**DOCKET NUMBER 50-483
CALLAWAY PLANT
UNION ELECTRIC COMPANY
RESPONSE TO REQUEST FOR ADDITIONAL INFORMATION
ON REVISION TO TECHNICAL SPECIFICATION 5.5.9
"STEAM GENERATOR (SG) TUBE SURVEILLANCE PROGRAM"**

**REQUEST FOR ADDITIONAL INFORMATION
REVIEW OF THE CALLAWAY PLANT APPLICATION
FOR REVISION TO TECHNICAL SPECIFICATION 3/4.4
TAC NUMBER: MB1214**

Figure R30-1

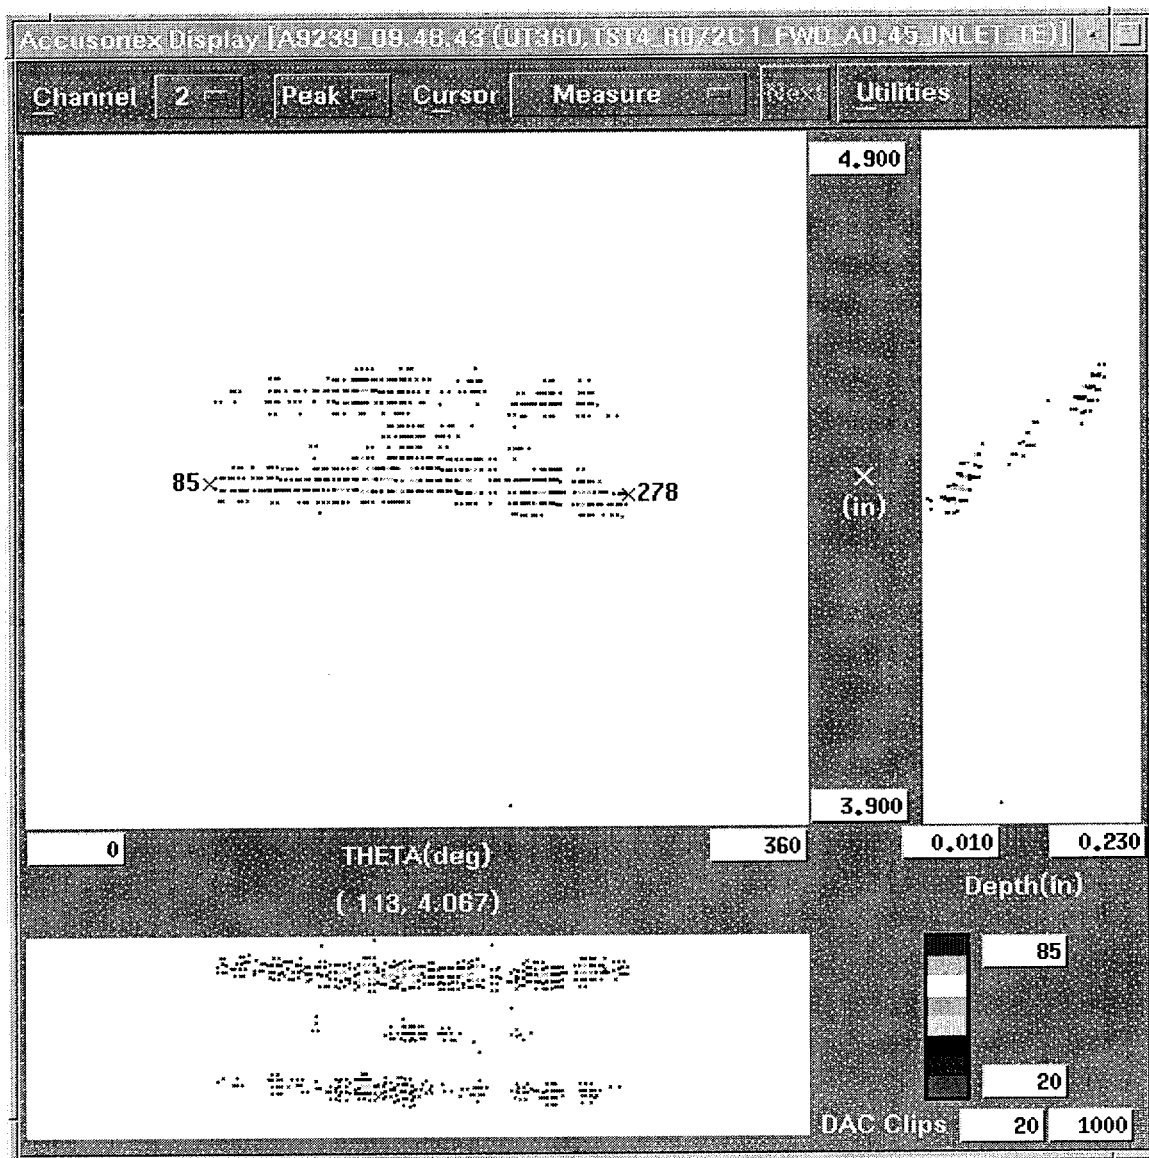
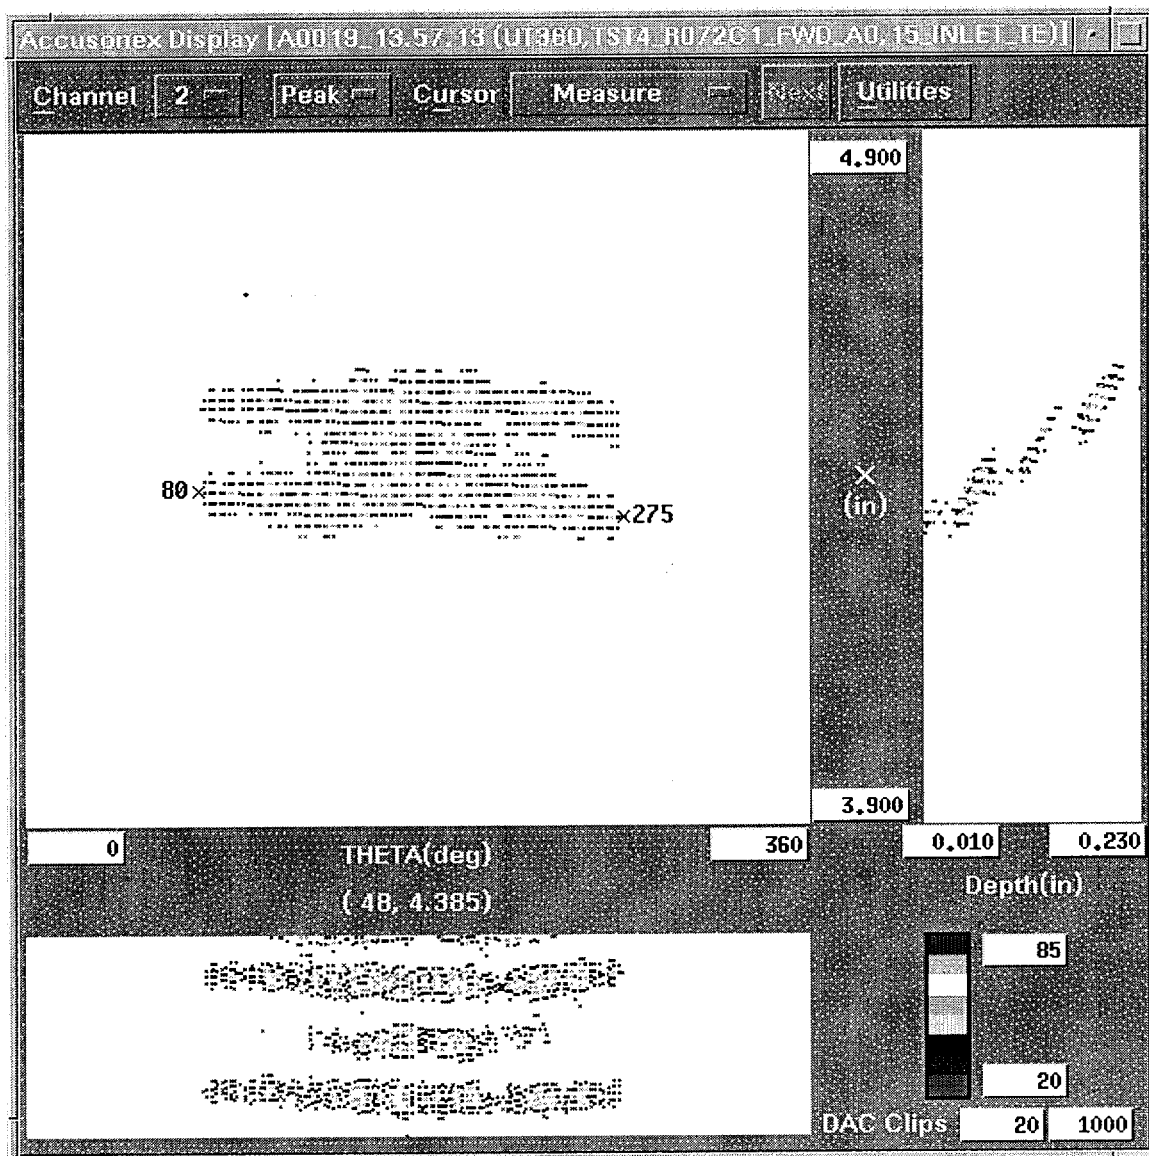
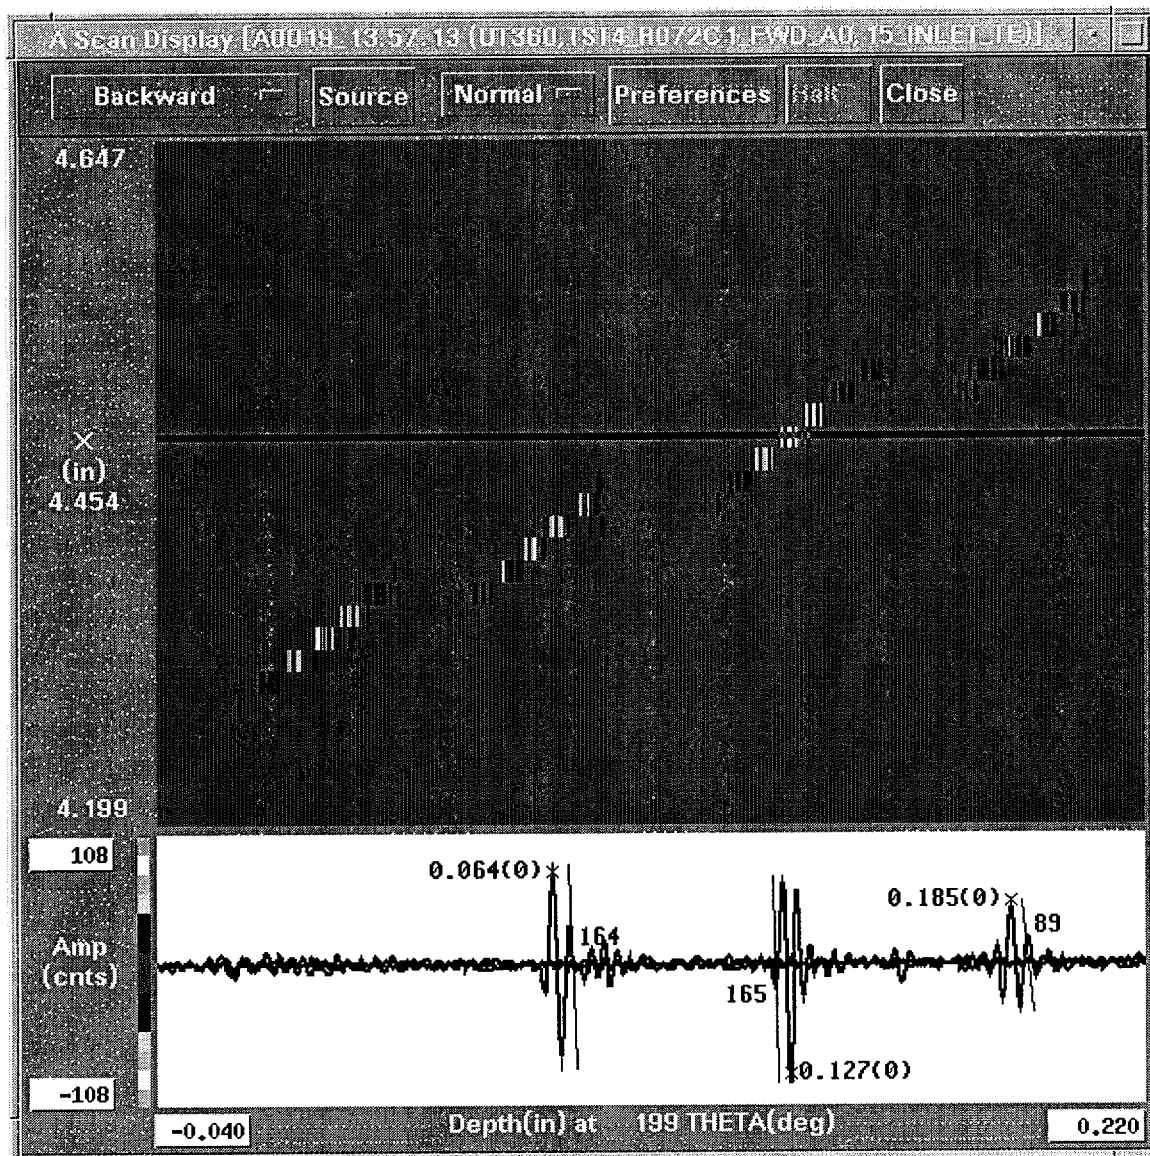
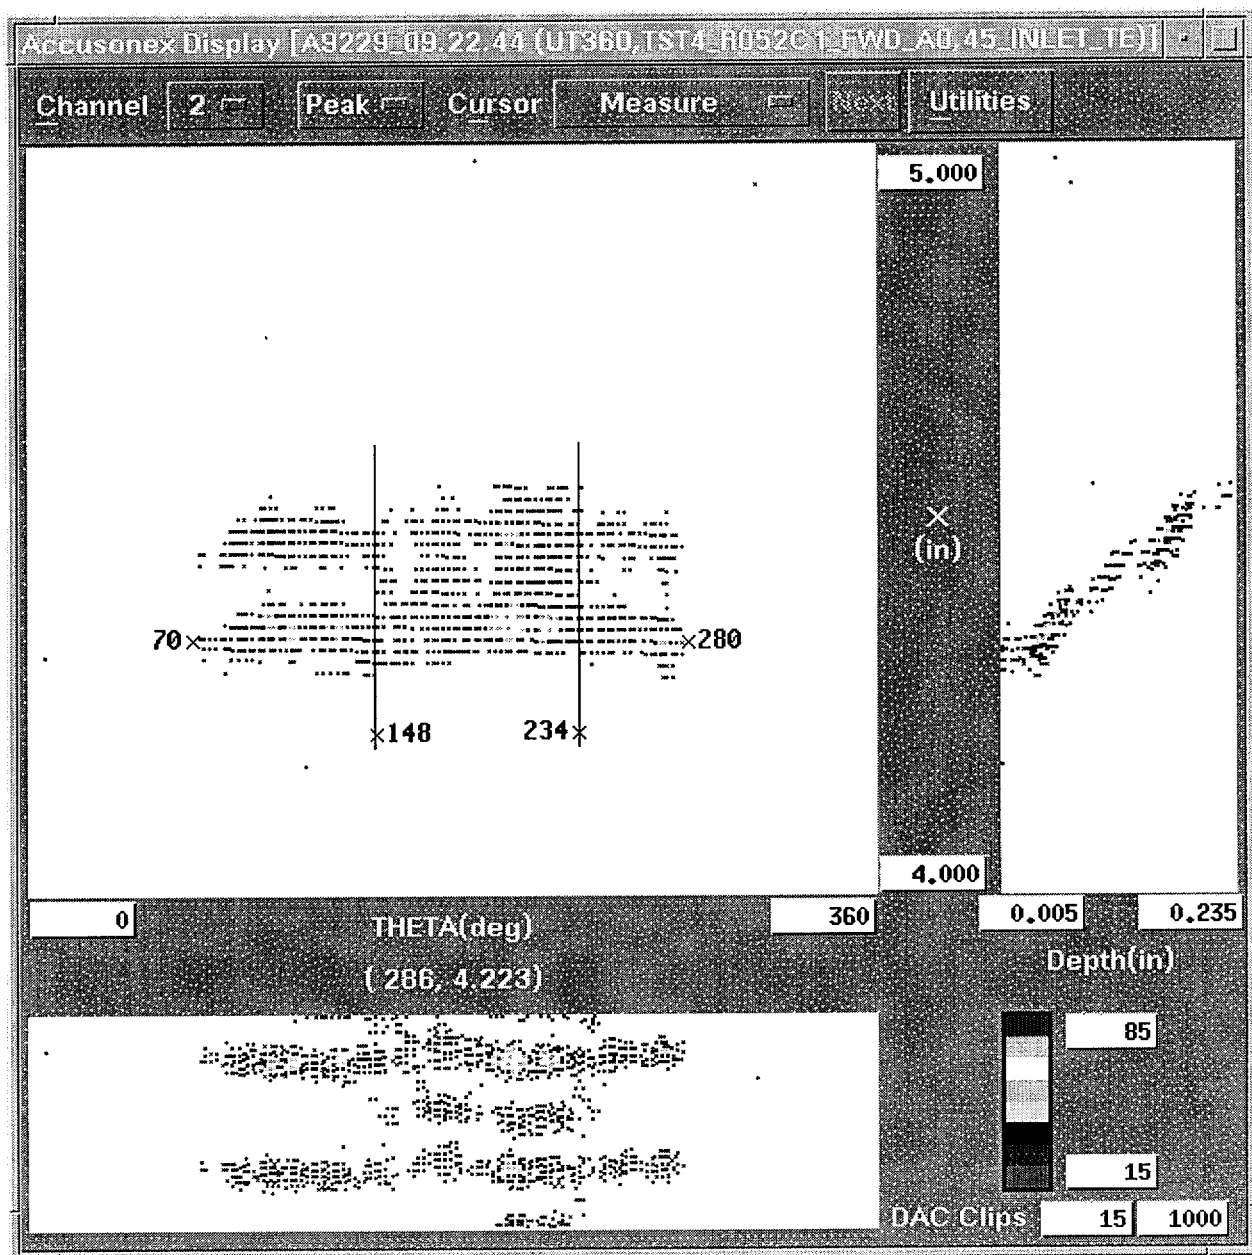
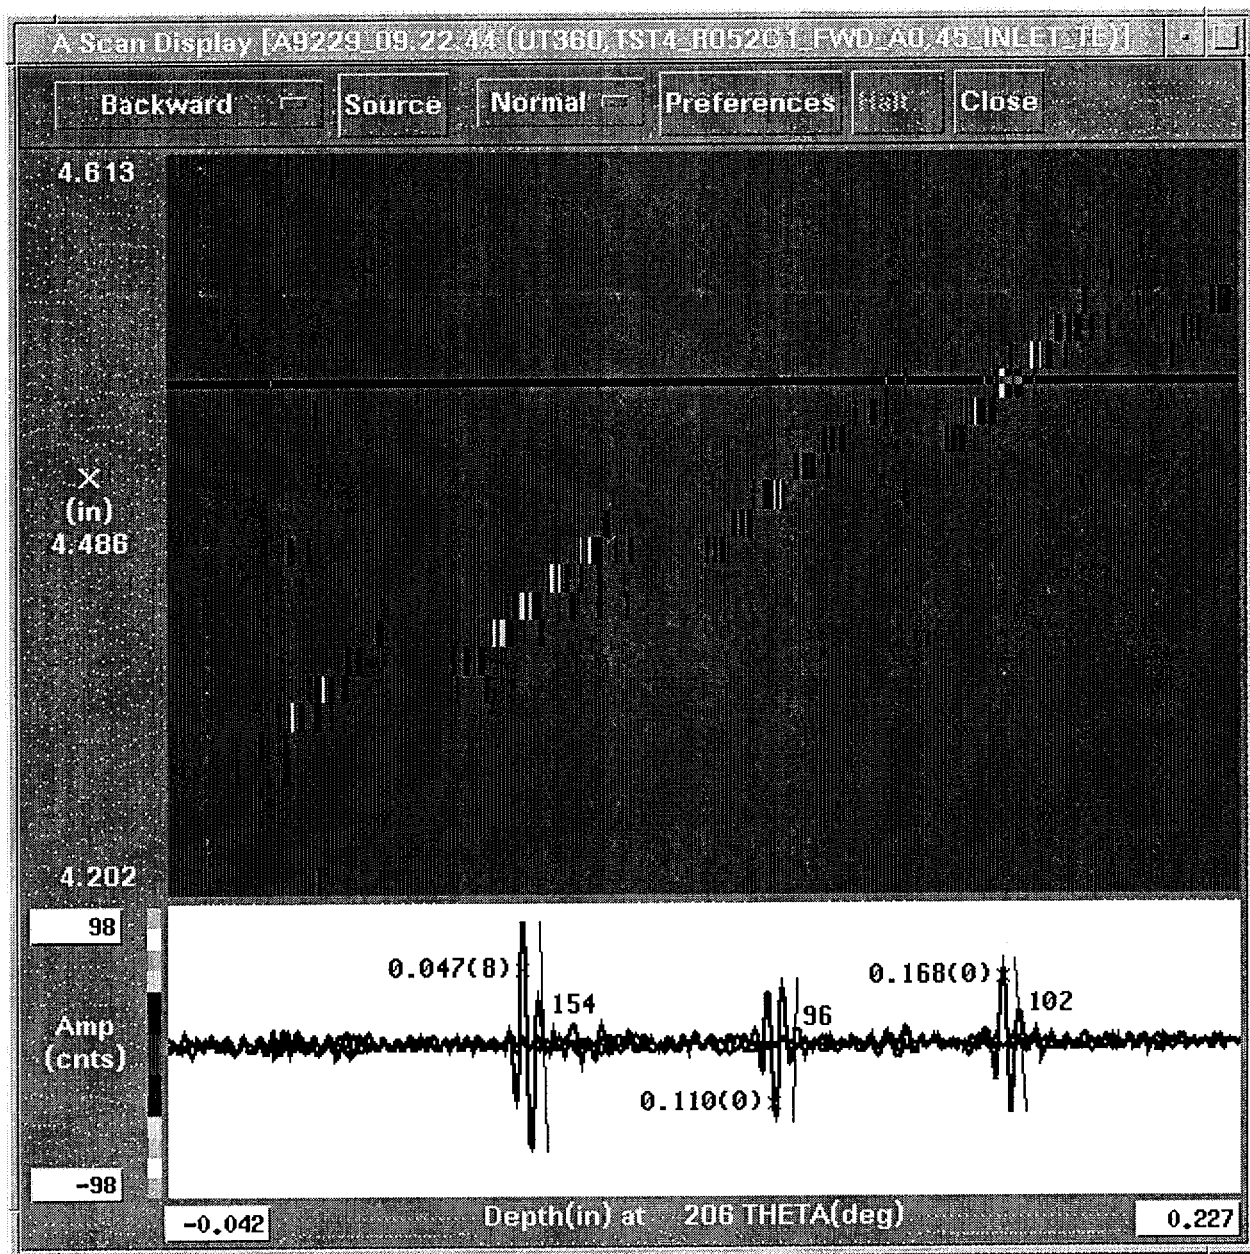
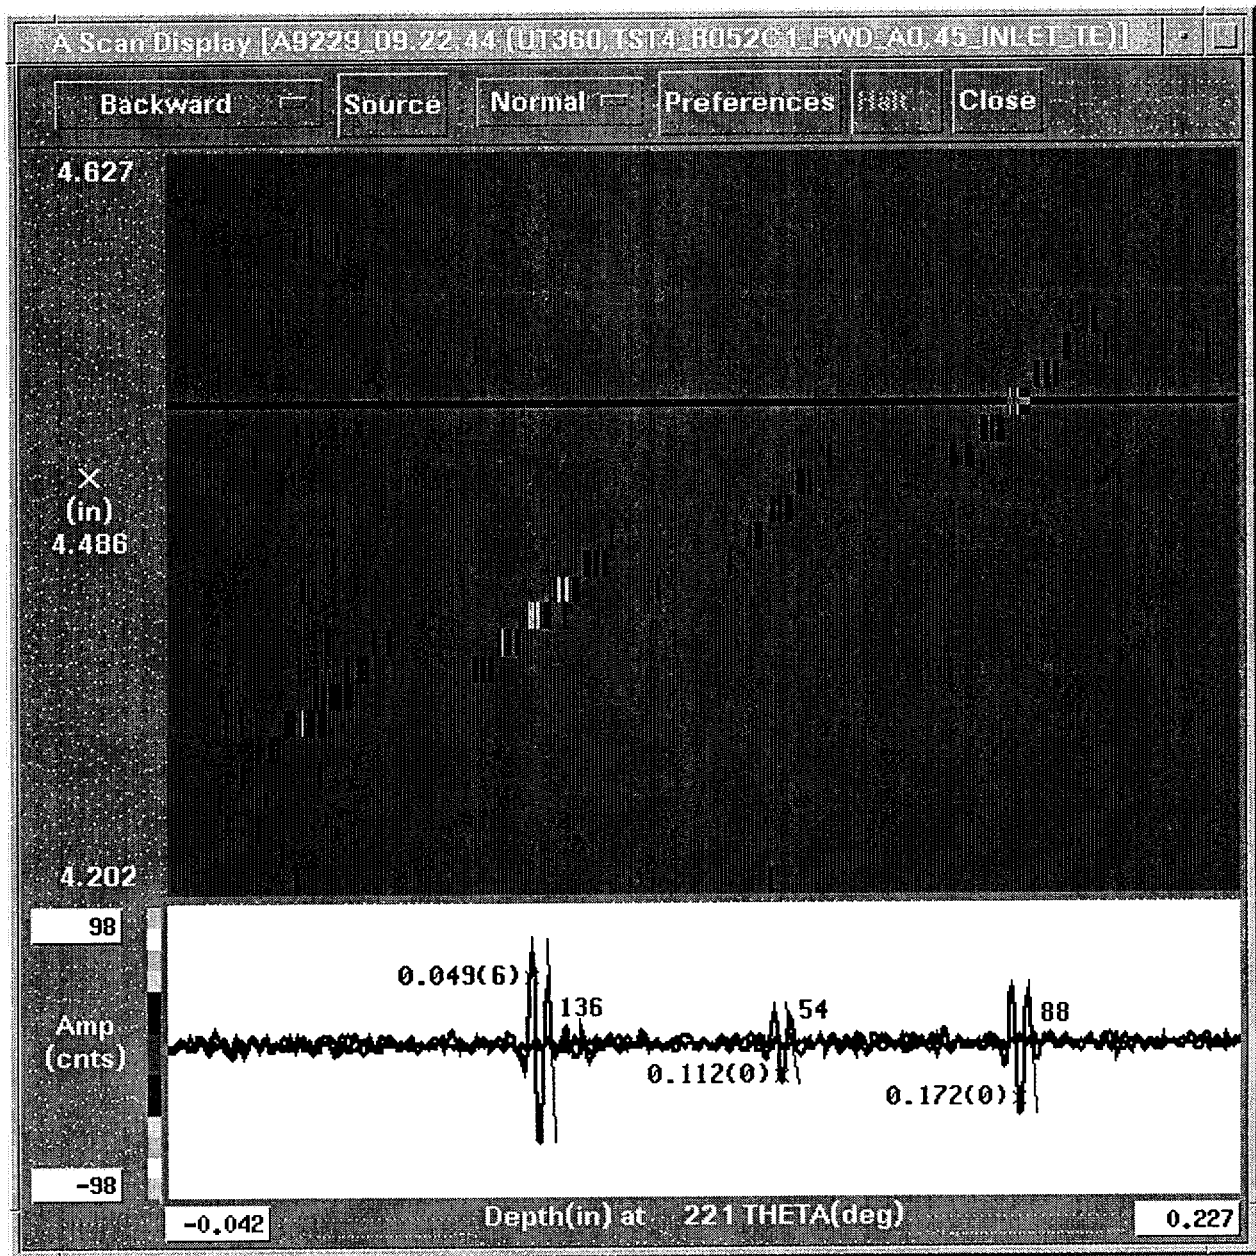
RAI # 30. The report states that “UT techniques have been shown to be effective in the detection and sizing of fatigue cracks propagated into the sleeve material.” Please provide data to support this assertion. (Page 11-57, BAW-10219P, Rev. 4)

This is the pre-fatigue crack C-Scan plot of the ODSCC circumferential crack in tube TST4-072-1. The crack extent (length) can be estimated from the C-Scan plot as $(278 - 85)$ or 193 degrees. The plot shows the presence of a half skip response, a one and one half skip response and some full skip reflections.

This is the post-fatigue crack C-Scan plot of the ODSCC circumferential crack in tube TST4-072-1. The crack extent (length) can be estimated from the C-Scan plot as $(275 - 80)$ or 195 degrees. The fatigue cycling has not significantly increased the crack extent (length). The plot shows the presence of a half skip response, a one and one half skip response and an increase in the full skip response.

This is the pre-fatigue crack C-Scan plot of the ODSCC circumferential crack in tube TST4-052-1. The crack extent (length) can be estimated from the C-Scan plot as $(280 - 70)$ or 210 degrees. The plot shows the presence of a half skip response, a one and one half skip response and some full skip reflections between the 148 degree and 234 degree locations along the crack extent.

This is the post fatigue crack C-Scan plot of the ODSCC circumferential crack in tube TST4-052-1. The crack extent (length) can be estimated from the C-Scan plot as (280 – 70) or 210 degrees. The plot shows the presence of a half skip response, a one and one half skip response and an increase in the full skip response between the 200 degree and 230 degree locations along the crack extent.

This is the post final deposition C-Scan plot of the ODSCC circumferential crack in tube TST4-052-1. The crack extent (length) can be estimated from the C-Scan plot as (275 – 70) or 205 degrees. The plot shows the presence of a half skip response, a one and one half skip response and the diminished amplitude of the full skip response.
